RENESAS TECHNICAL UPDATE

Classification of Production	MPU&MCU		No	TN-SH7-497A/E	Rev	1
THEME	Modification of the Reset Sequence of HCAN2 of SH7760		Classification of Information	<ol style="list-style-type: none"> 1. Spec change 2. Supplement of Documents 3. Limitation of Use 4. Change of Mask 5. Change of Production Line 		
PRODUCT NAME	SH7760	Lot No.	Reference Documents	SH7760 hardware manual (ADE-602-291)	Effective Date	
		All			Eternity

- The figure 22.5 Reset Sequence of the 22.6.2 HCAN2 Settings

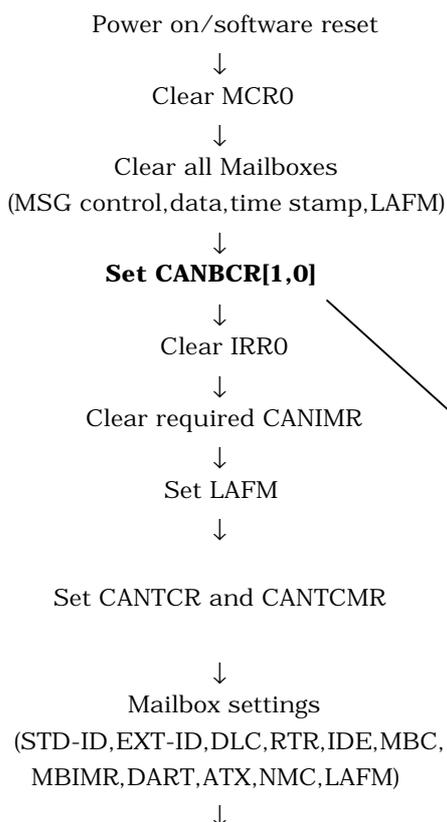
There is the following modification about the Reset Sequence of HCAN2 of SH7760.

Please set CANBCR[1:0] immediately after the Mailbox Setting.
